RE: Draft Environmental Impact Report for the Stoneridge Commerce Center Project (SCH
#2020040325)

Thank you for the opportunity to provide comments on Riverside County's Draft Environmental Impact Report (DEIR) for the Stoneridge Commerce Center (the Project). The Project would site over 9.5 million square feet of total warehouse space just east of the City of Perris on and adjacent to several Native American tribes' Traditional Cultural Landscape. Because the Project is located more than six miles away from the nearest highway via the preferred truck route, the Project would result in thousands of daily truck trips passing homes and a middle school in Perris. The County should consider other truck routing options to minimize the Project's impacts to sensitive receptors. The DEIR also does not properly analyze the Project's impacts to sensitive receptors, as it commits several material errors in the air quality analysis, and fails to disclose and sufficiently analyze significant traffic noise impacts. Moreover, the DEIR fails to adequately analyze the Project's cumulative impacts on tribal cultural resources, or to adequately incorporate the information provided by impacted tribe

Exhibit A: Annotated Maps of the Primary and Southern Truck Routes

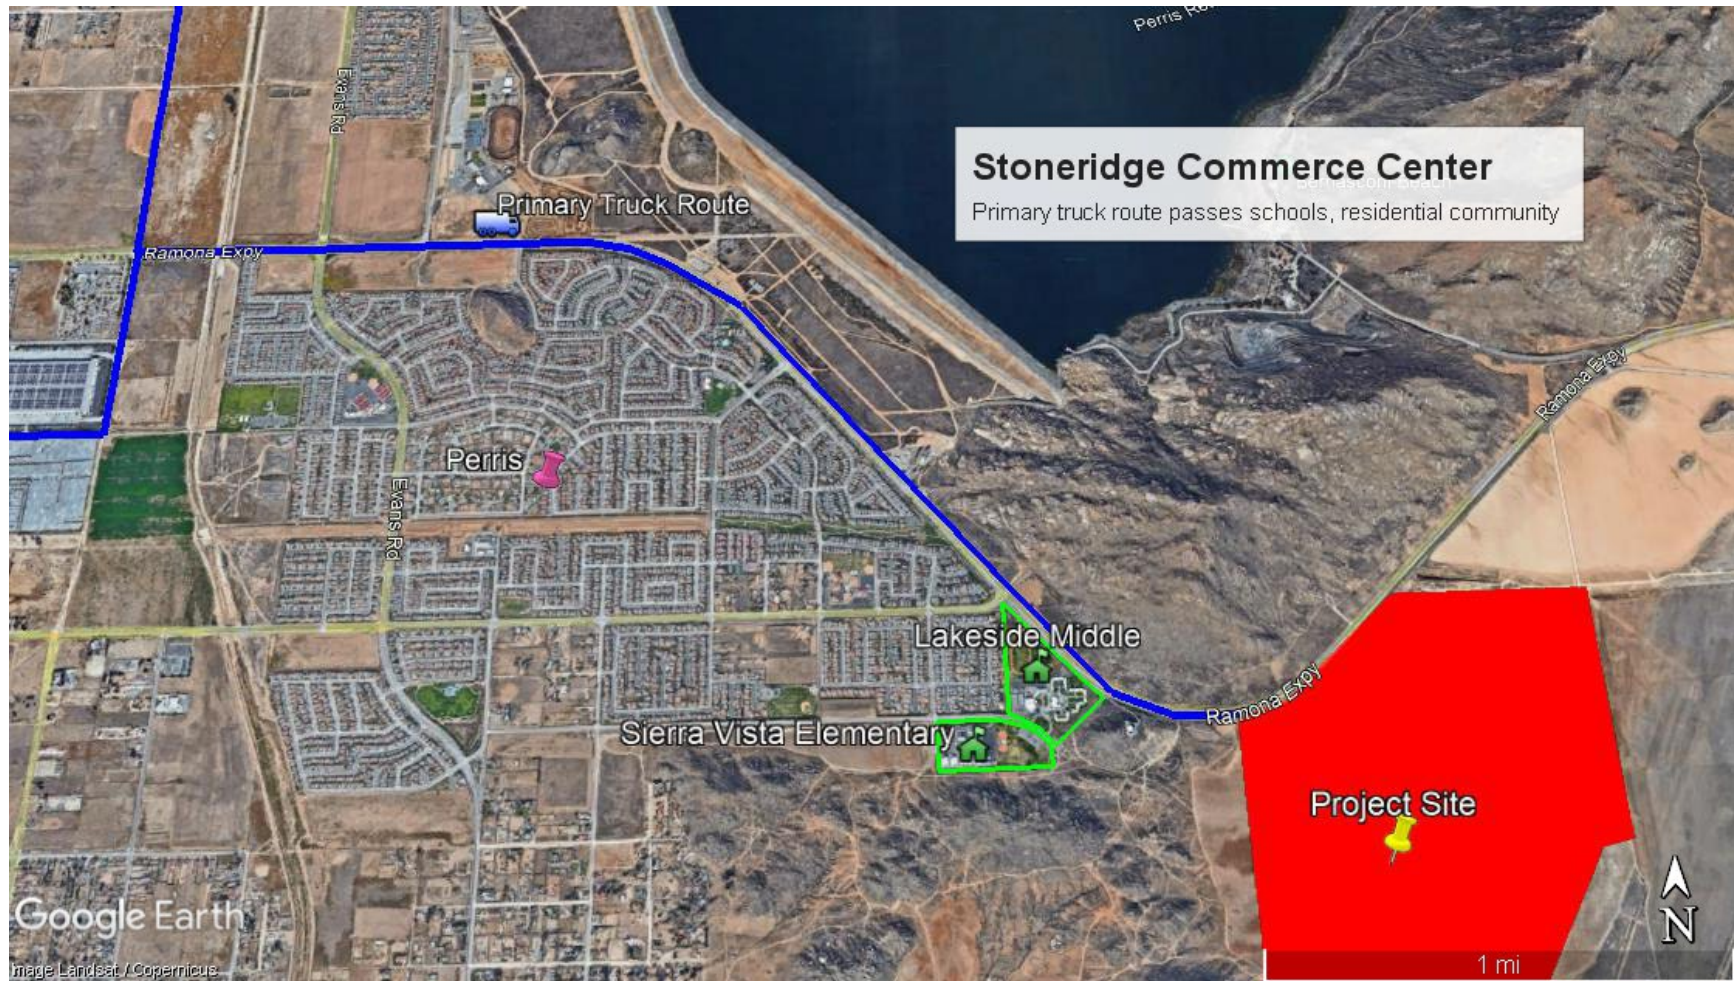
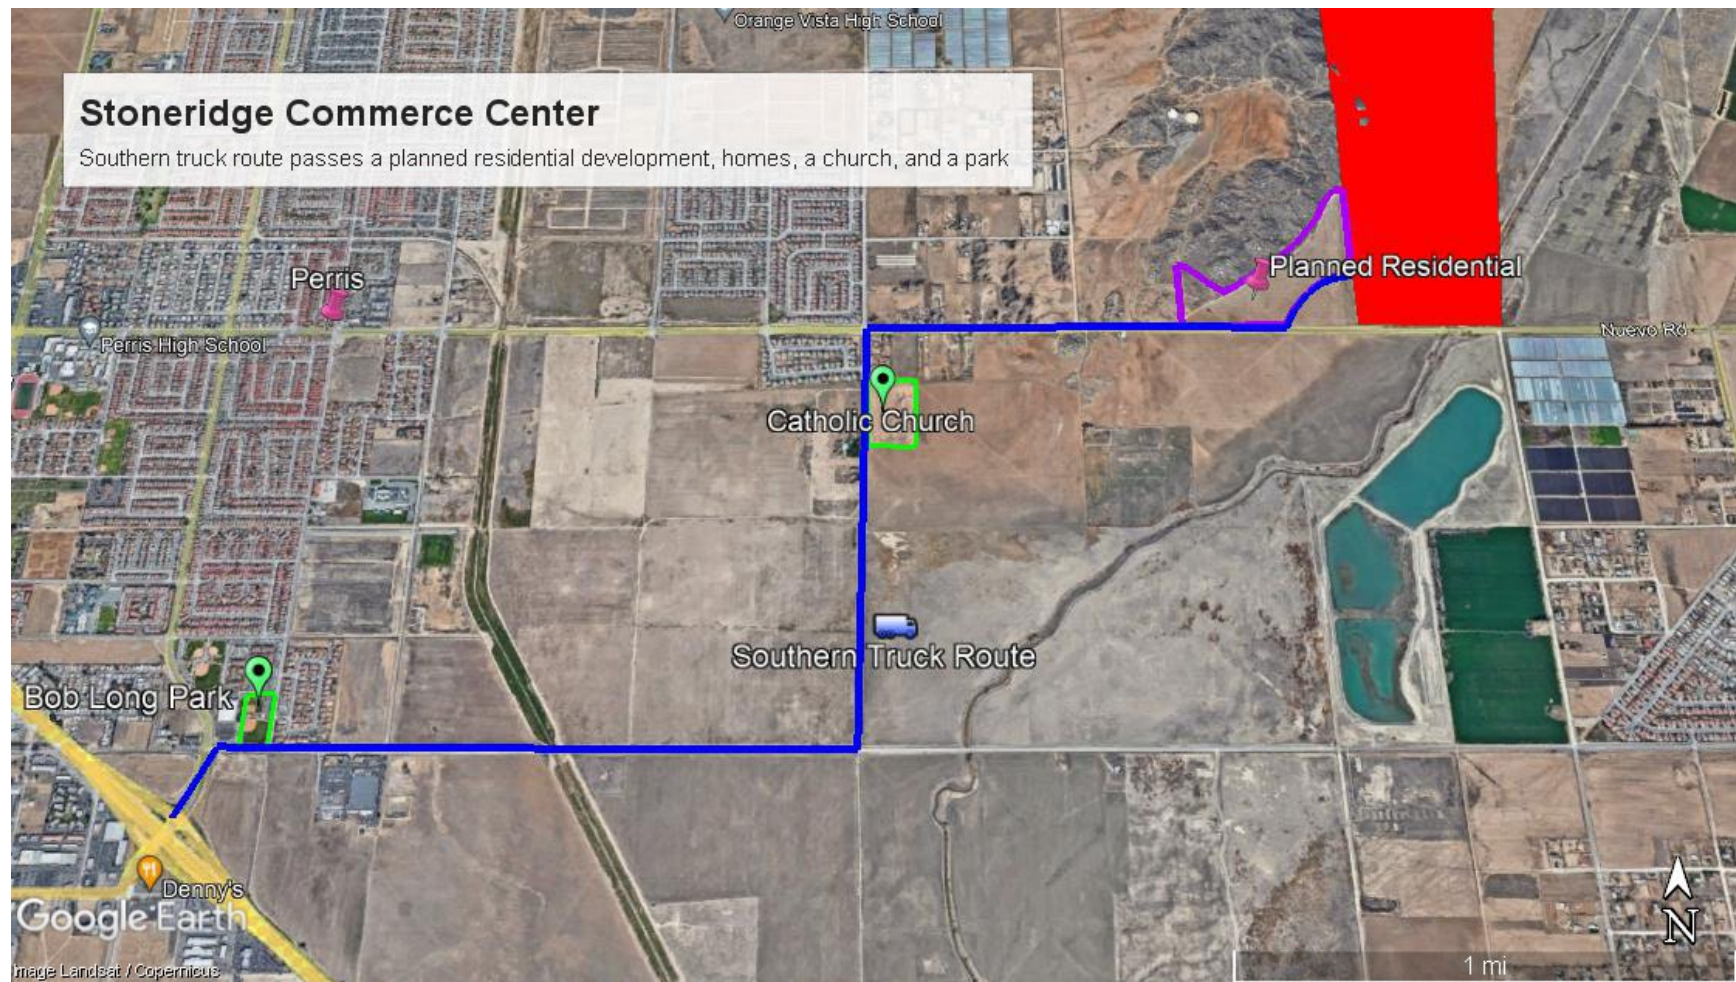
The DEIR proposes two alternative truck routes to accommodate the Project's nearly 4,000 expected daily truck trips, both of which would lead to thousands of daily truck trips passing residences and sensitive receptors.⁴⁷ The Primary Truck Route plan would direct 98 percent of the Project's truck traffic along a six-mile route to the highway via Ramona Expressway, which borders Lakeview Middle School and a large residential community in

Perris.⁴⁸ The Southern Truck Route plan would still direct 60 percent of trucks (2,350 trucks daily) along Ramona Expressway, but 38 percent (1,488 trucks daily) would take a four-mile path via Nuevo Road, passing the planned residential development of McCanna Hills, two smaller residential communities, a church, and a public park.⁴⁹

In addition to inadequately analyzing the adverse impacts to air quality and noise that these truck routes pose for sensitive receptors, as described above, the DEIR has incorrectly assumed that trucks on the Primary Truck Route would use the Ramona Expressway to access Interstate 215 in the east. The City of Perris, through which that stretch of Expressway traverses, has removed that portion of the Expressway as a truck route. According to Perris, the City removed the “entire stretch of Ramona Expressway as a truck route” under the Perris Valley Commerce Center Specific Plan, which the City adopted in January 2012, thus removing an approximately 2.5-mile stretch of Primary Truck Route located within Perris’s city limits along the Ramona Expressway.⁵⁰ As such, in accordance with Perris’s restriction, 98 percent of the Project truck traffic based on the Primary Truck Route plan, or 60 percent of the Project truck traffic based on the Southern Truck Route plan, is not viable.

The DEIR should therefore reconsider the truck routes it proposes to service the Project site to avoid the Ramona Expressway. One alternative is to redirect most of the truck traffic to the south; but instead of using the path planned under the Southern Truck Route, a new southern route could be used to divert trucks away from the sensitive receptors along the Southern Truck Route (the planned residential development of McCanna Hills, the two smaller residential communities, the church, and the public park). The alternative southern route would require the expansion in capacity of existing roads and the construction of a new highway interchange. For example, Dawson Road, whose northern terminus does not intersect any existing roads, could be extended to intersect with Nuevo Road to divert truck traffic south along Dawson Road immediately after departing the Project site. Trucks could then head west on San Jacinto Avenue, south on Dunlap Drive, followed by west on Ellis Avenue. To accommodate truck traffic onto Interstate 215 without routing trucks past major sensitive receptors, the County could consider the construction of an Interstate 215 highway interchange at Ellis Avenue, subject, of course, to approvals from Riverside County Transportation Commission and other relevant municipalities and agencies.

Exhibit B: Annotated Map of the Project Vicinity

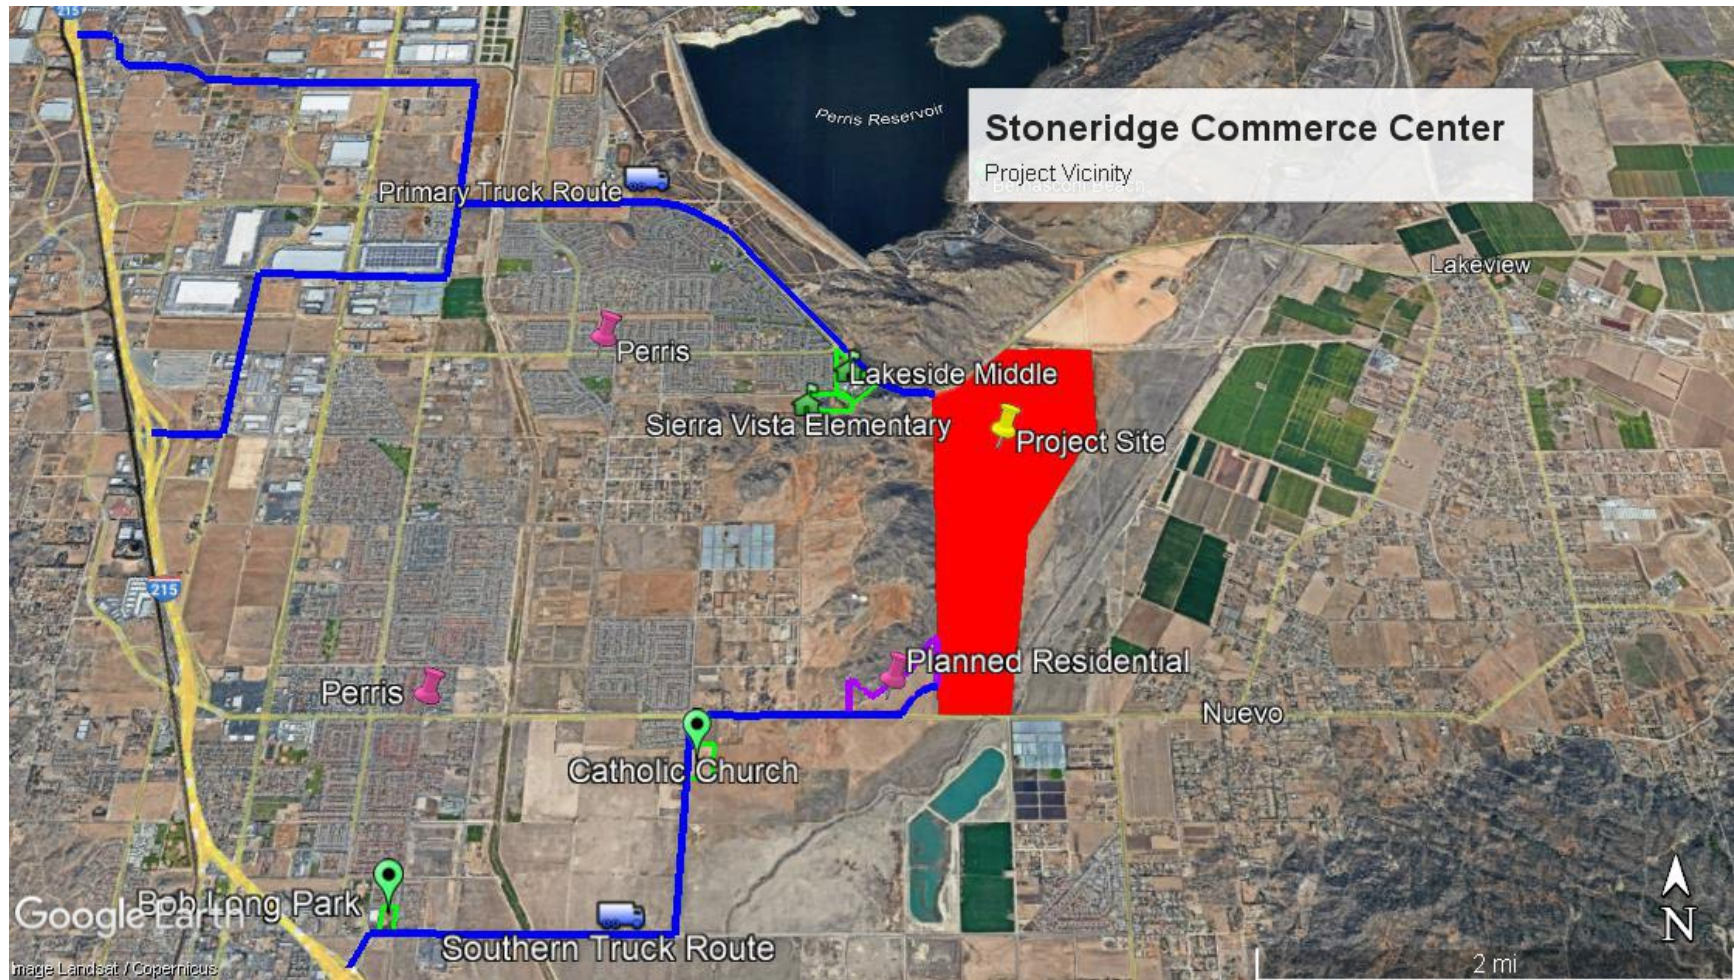
The Project would primarily impact three communities in Perris: the community bordering Ramona Expressway, the communities along the Southern Truck Route, and the planned McCanna Hills community. Ramona Expressway forms the northern border of a large residential community in Perris. Homes back up to Ramona Expressway along the entire 1.5-mile stretch from Rider Street to Avalon Parkway. The homes are slightly recessed into the ground, such that Ramona Expressway is approximately level with the homes' second stories. A short wall separates the homes from the road, but the wall does not shield second story windows

from traffic. Lakeside Middle School also backs to Ramona Expressway, with recreational facilities, including a baseball field and running track, adjacent to the road. Other sensitive receptors within 1,000 feet of the Primary Truck Route include Sierra Vista Elementary School, Avalon Elementary School, Frank Eaton Memorial Park, and hundreds of homes. According to CalEnviroScreen 4.0, CalEPA's screening tool that ranks each census tract in the state for pollution and vulnerability,⁷ while this community is not currently heavily polluted besides the region's extreme ozone pollution, it scores highly (73rd percentile) on population characteristics indicating greater vulnerability to pollution. For example, the community has greater rates of cardiovascular disease than 91 percent of other census tracts in California, and it has higher than average rates of asthma and newborns with low birth weight. The community also ranks in the upper half of all but one of CalEnviroScreen's socioeconomic vulnerability factors.⁸ About 81 percent of students enrolled at Lakeside Middle School are eligible for the Free or Reduced-Price lunch programs, meaning that these students come from families whose income are below CalEnviroScreen's poverty threshold, and 95 percent of the student population identify as persons of color.⁹ Among all residents of this community, the majority (64 percent) identified as Hispanic, and 86 percent of residents identified as a race/ethnicity other than white.

The communities along the Southern Truck Route include sensitive receptors on Nuevo Road, Dunlap Drive, and San Jacinto Avenue. Sensitive receptors on Nuevo Road include a handful of rural-style homes and a small suburban development at the intersection of Nuevo Road and Dunlap Drive. More suburban homes border Dunlap Drive, along with St. James the Less Catholic Church. Near Interstate 215, several suburban homes and Bob Long Park are adjacent to East San Jacinto Avenue. Because these communities span several census tracts, precise data on their pollution burden and demographic vulnerability to pollution do not exist, but the CalEnviroScreen data for these census tracts are relatively similar to one another. All suffer from significant ozone pollution and above average amounts of other pollutants—for example, pesticides in some census tracts, diesel particulate matter and traffic in others. Like the community bordering Ramona Expressway, the communities along the Southern Truck Route have high rates of cardiovascular disease, asthma, and low birth weight babies, and they rank in the upper half of all CalEnviroScreen measures of socioeconomic vulnerability except unemployment. These communities have a similar racial/ethnic makeup to the community bordering Ramona Expressway, with a majority of residents identifying as Hispanic, and the overwhelming majority identifying as non-white.
